SECTION 4.55(1A) MODIFICATION APPLICATION CROWN SYDNEY HOTEL RESORT (SSD 6957)

This application has been prepared by Ethos Urban on behalf of Crown Sydney Hotel Resort (Crown) pursuant to section 4.55(1A) of the *Environmental Planning and Assessment Act 1979* (EP&A Act) to modify Development Consent SSD 6957 (Development Consent) relating to the approved Crown Sydney Hotel Resort located at 51a Hickson Road, Barangaroo, NSW.

Figure 1 Approved Level 48

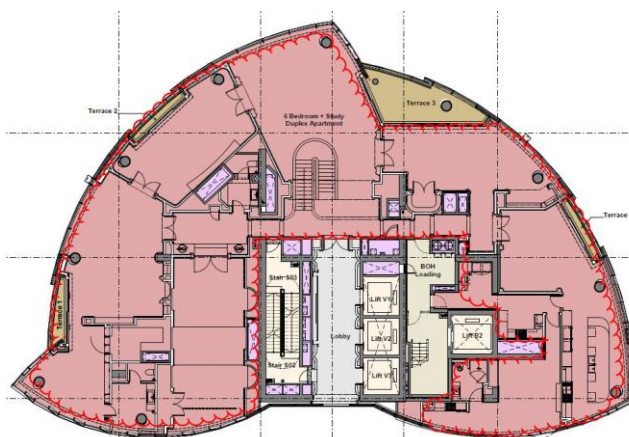
The proposed modification to the development consent comprises the amalgamation of some apartments in response to a specific buyer request in relation to apartments on Levels 48 and 49. These modifications result in a decrease in the total number of residential apartments from 81 to 76 as currently approved under SSD 6957 Mod 2.

An example of the proposed changes is indicated below at **Figure 1** and **2** for Level 48. Proposed modifications are also indicated at **Attachment A**.

As detailed above, the proposed amendments involve the amalgamation of existing apartments on Levels 48 and 49, in turn necessitating changes to the internal arrangements of floor layouts on these levels. The proposed amendments principally involve a reshuffling of approved apartment layouts within the approved building, which has been driven by a specific purchaser request for amendments to provide a residential apartment product that they desire.

Based on the detailed design revisions of the internal apartment layouts, six (6) apartments are proposed to be amalgamated into one (1) apartment, of which is commensurate with the luxury residential market that is the target of the Crown development. Importantly, the proposed internal reconfigurations and amalgamation of apartments will not change the approved maximum residential GFA.
